Service Bulletin

Bulletin No.: 24-NA-133

Subject: Wheel Drive Shaft Retention Snap Ring Design Change

6690539

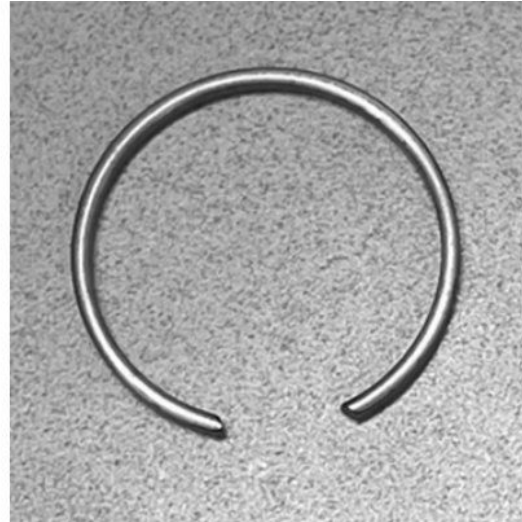
On vehicles equipped with ball-spline wheel drive shaft, the presence of a service groove (as shown below) on the inboard housing means the drive unit is equipped with the 2nd design 3-Point snap ring.

Round Ring First Design: PN 24048716
